Sent: 11/07/2023 10:59:13 PM
Subject: Re 4 Delmar Parade Dee Why Sydney North Planning Panel Virtual Presentation July 12 10 am
Attachments: Comments for DA 4 Delmar Pde to accompany 3 Senario Sketches.docx; Existing Situation as to SRBG's boundary 11072023.pdf; Proposed DAs Silouette to SRBG's boundary 11072023.pdf; Preferred Stepped Option to SRBG's boundary 11072023_0001.pdf;

Re DA 2022/0145 : 4 Delmar Pde, Dee Why

Submission of 3 X-Sections that I wish to refer to during my 3 minute presentation to the Sydney North Planning Panel, July 12

EXISTING SITUATION : X SECTION THRU BBQ PICNIC AREA

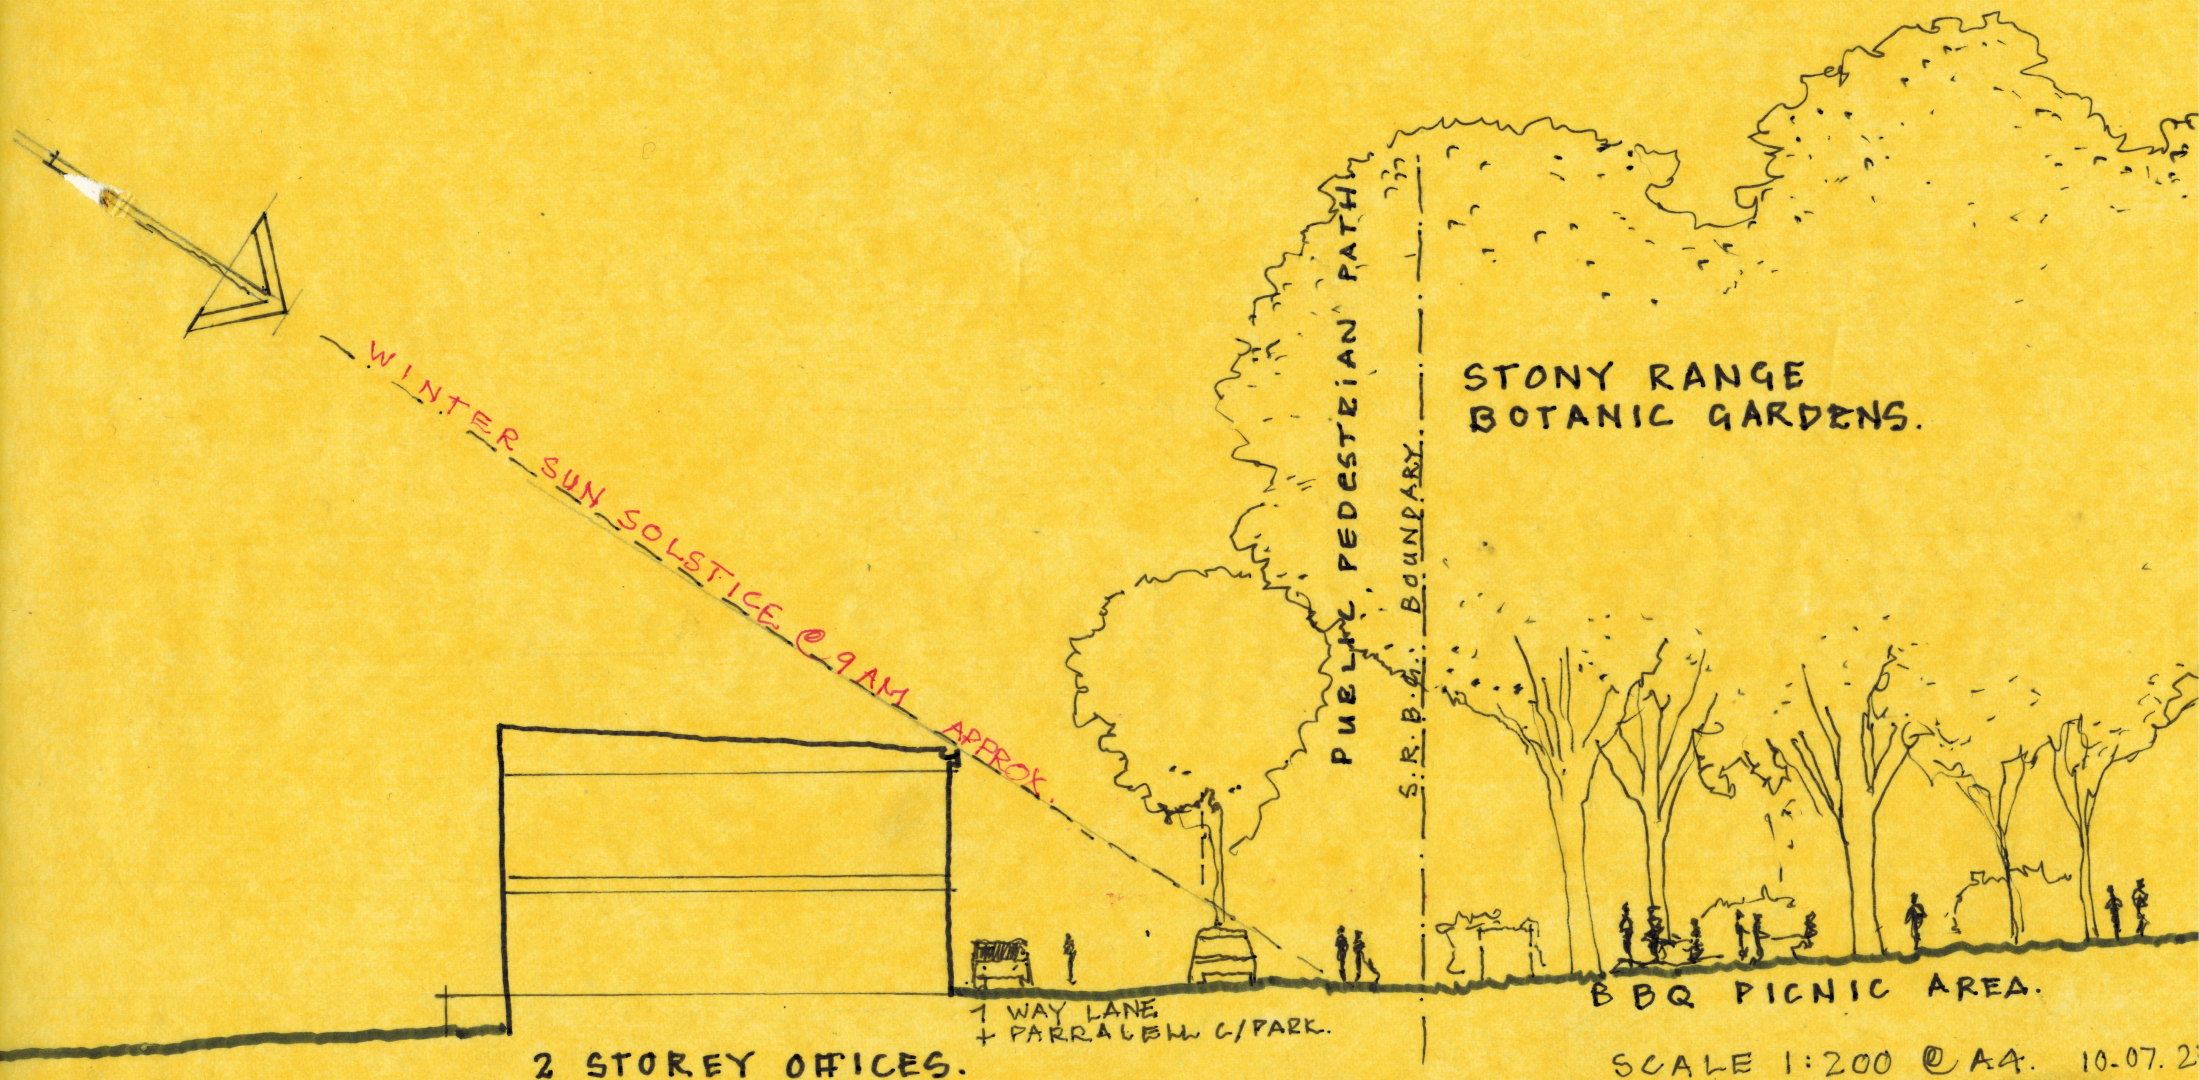
I am forwarding these 3 sketches describing in principle, how the above DA might modify its southern- most boundary towards Stony Range Botanical Gardens in order to arrive at a solution that benefits both applicant and the region's general public who after all are the custodians, users and visitors to this rare piece of public pleasure.

These sections are taken approximately adjacent to the BBQ Picnic area in the mid northern flatter section of the Botanical Gardens.

This part of the garden accommodates picnics, get-togethers, birthdays, natural play areas for kids as well as a quiet place to sit soak up the low laying winter morning sun.

PROPOSED DA

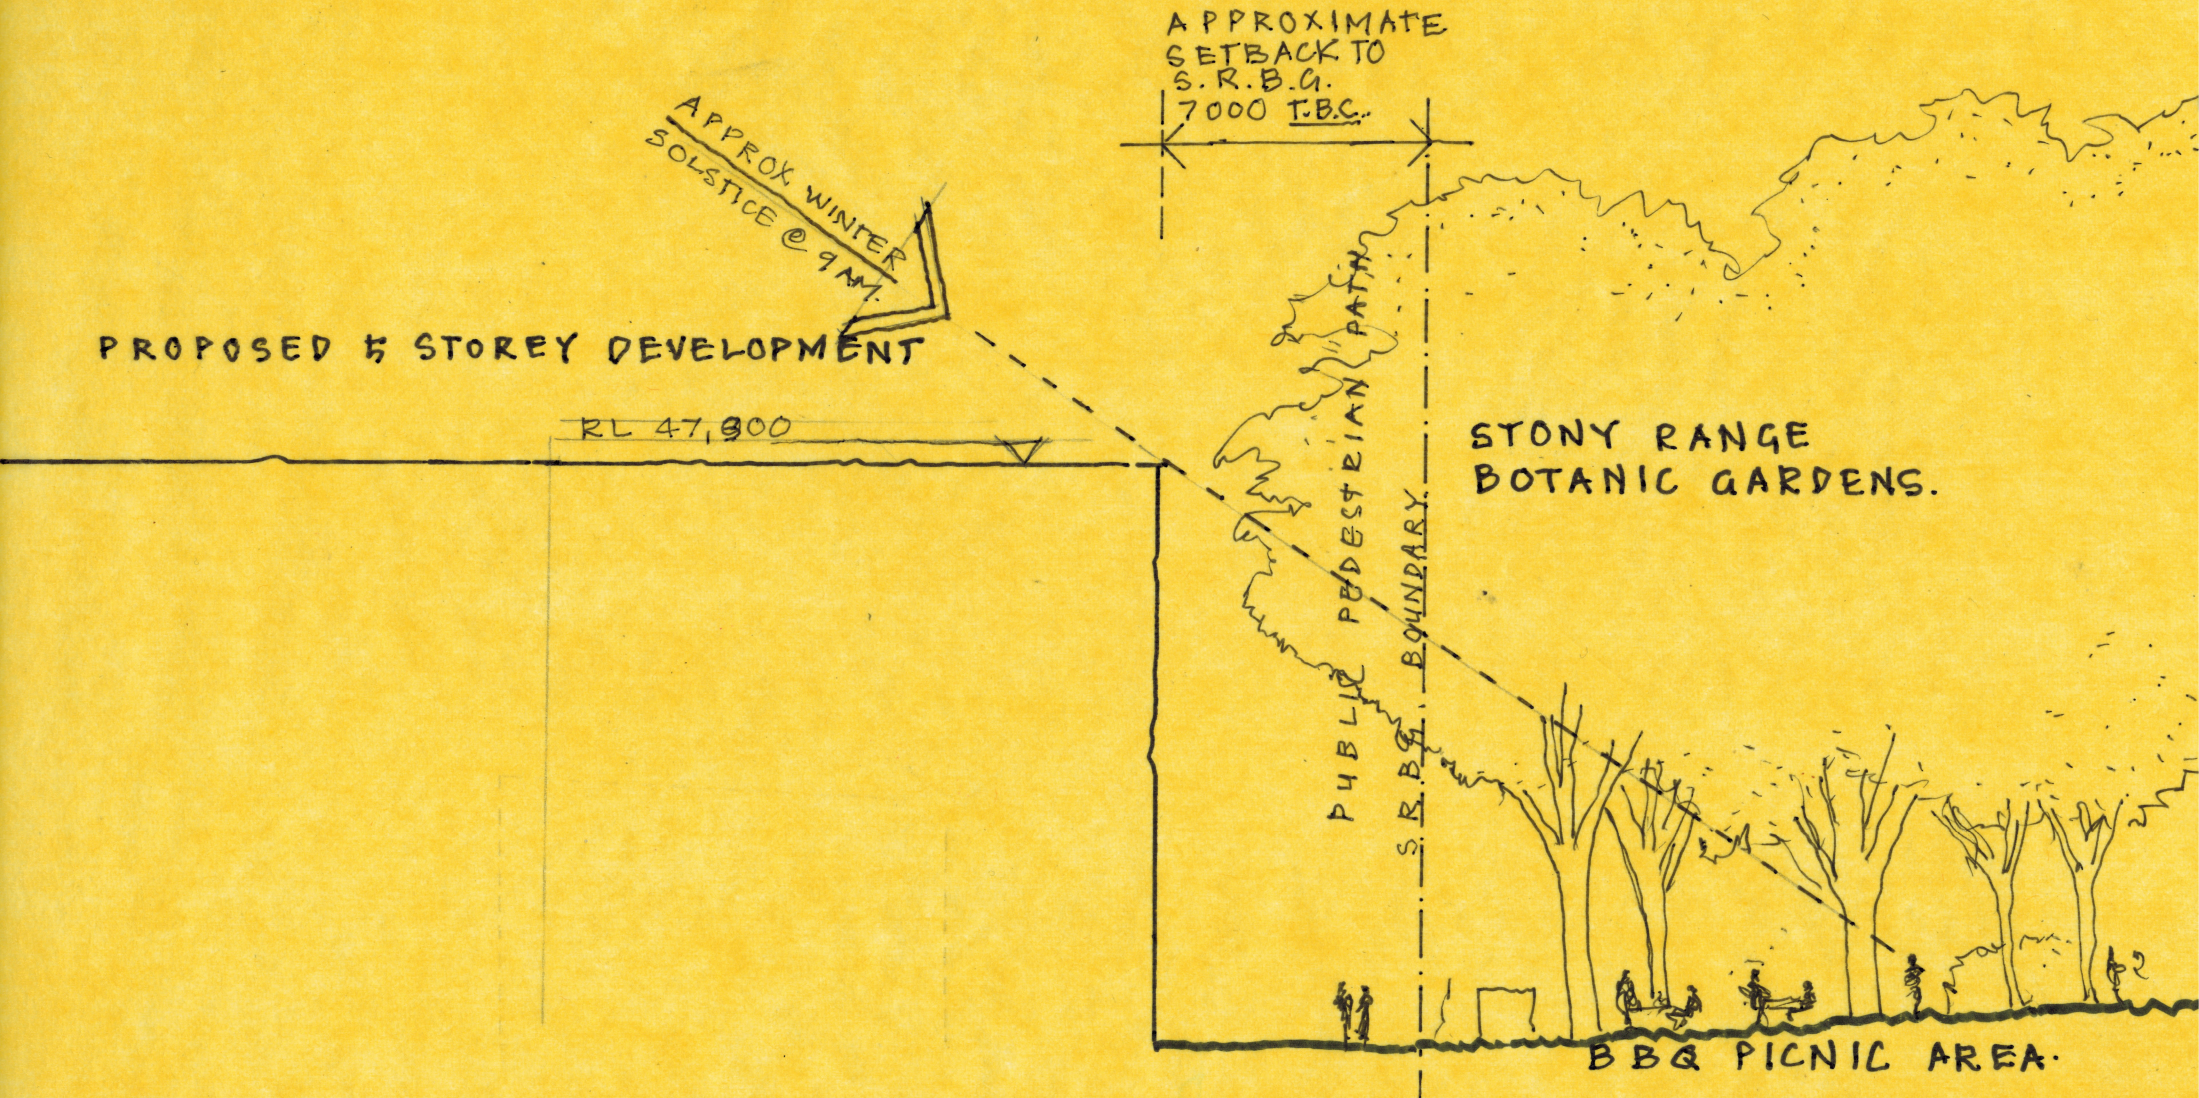
APPROX WINTER SOLSTICE @ 9 AM

APPROXIMATE SETBACK TO S.R.B.G. 7000 T.B.C.

PROPOSED 5 STOREY DEVELOPMENT

PREFERRED STEPPED.

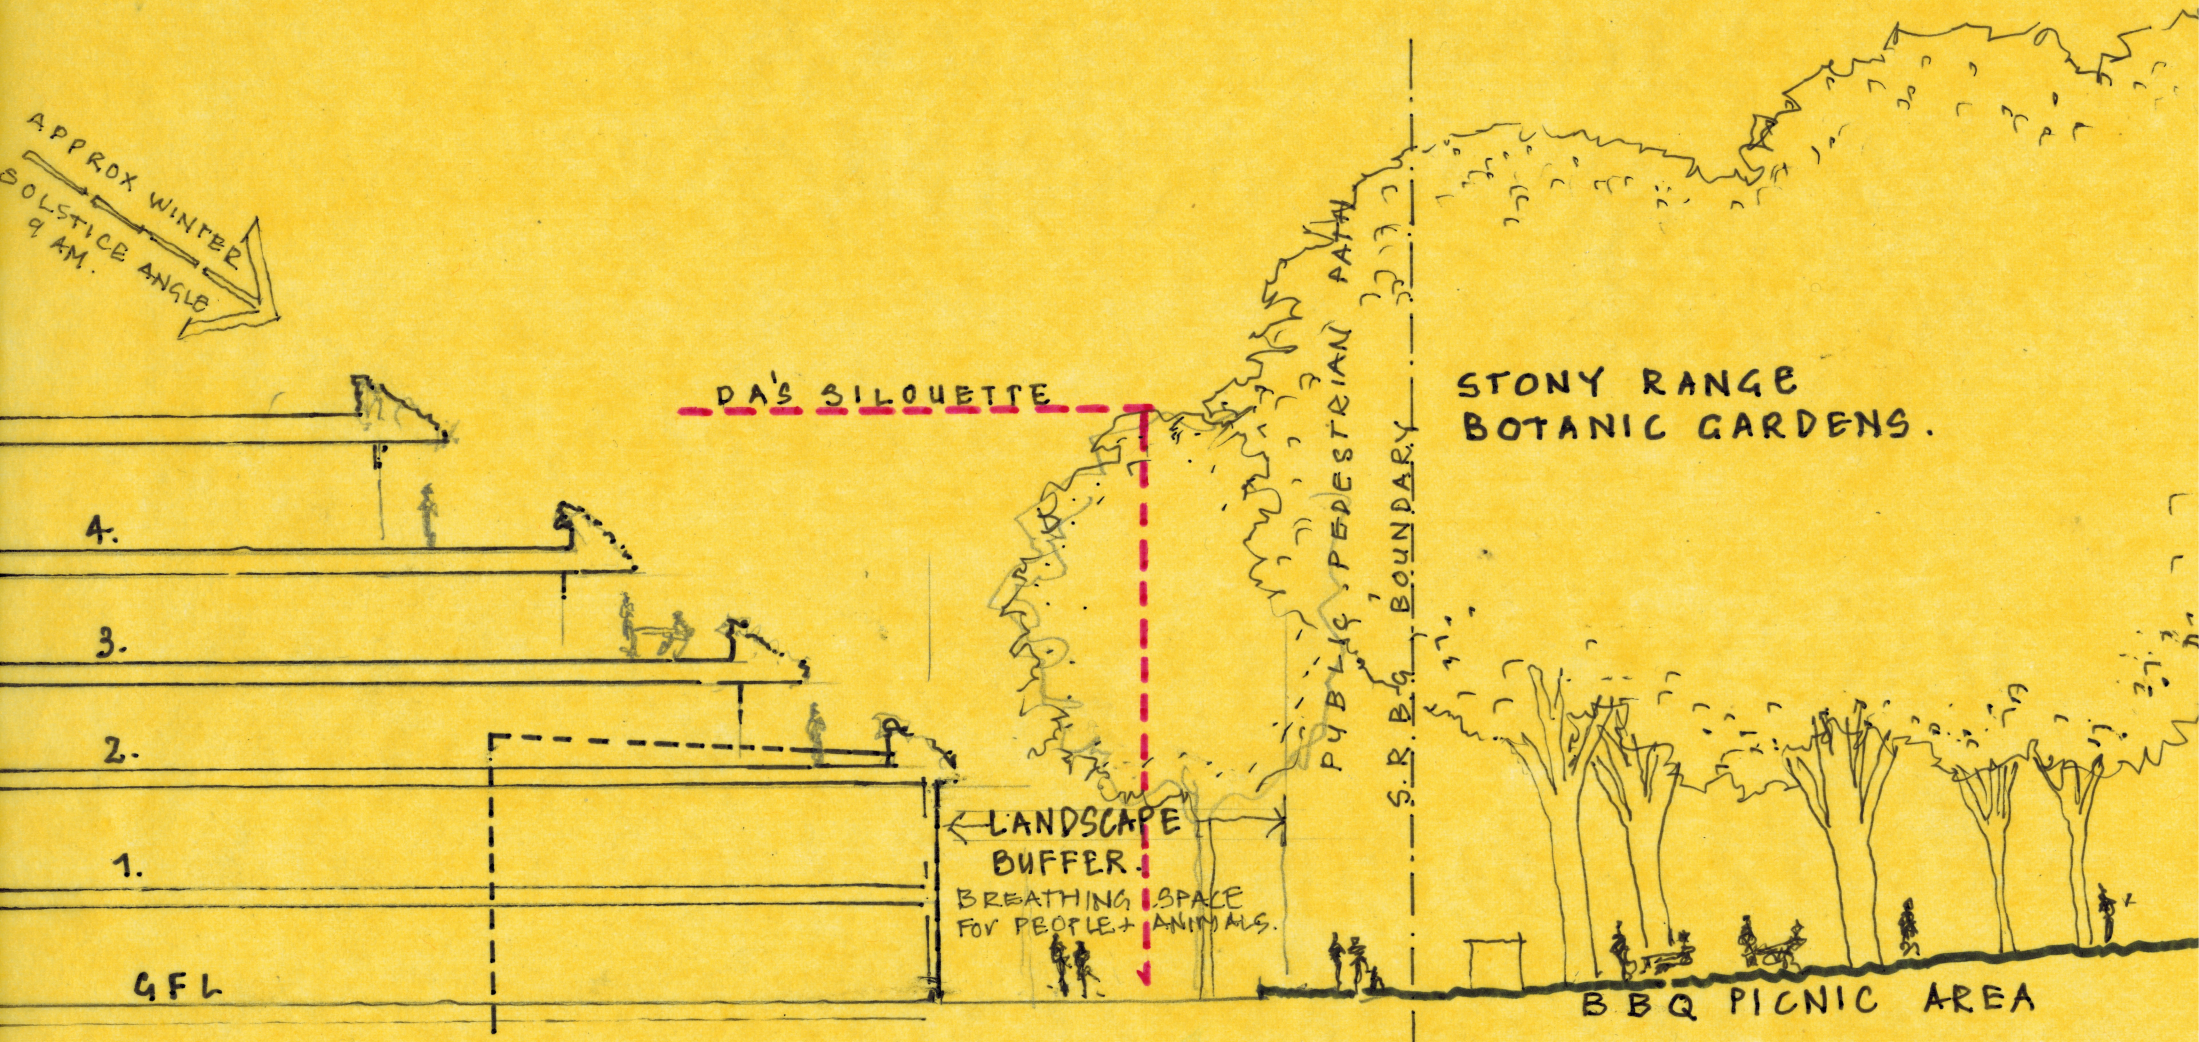
- Existing
- Proposed DA
- Possible modified Stepped Section with Landscaped Buffer
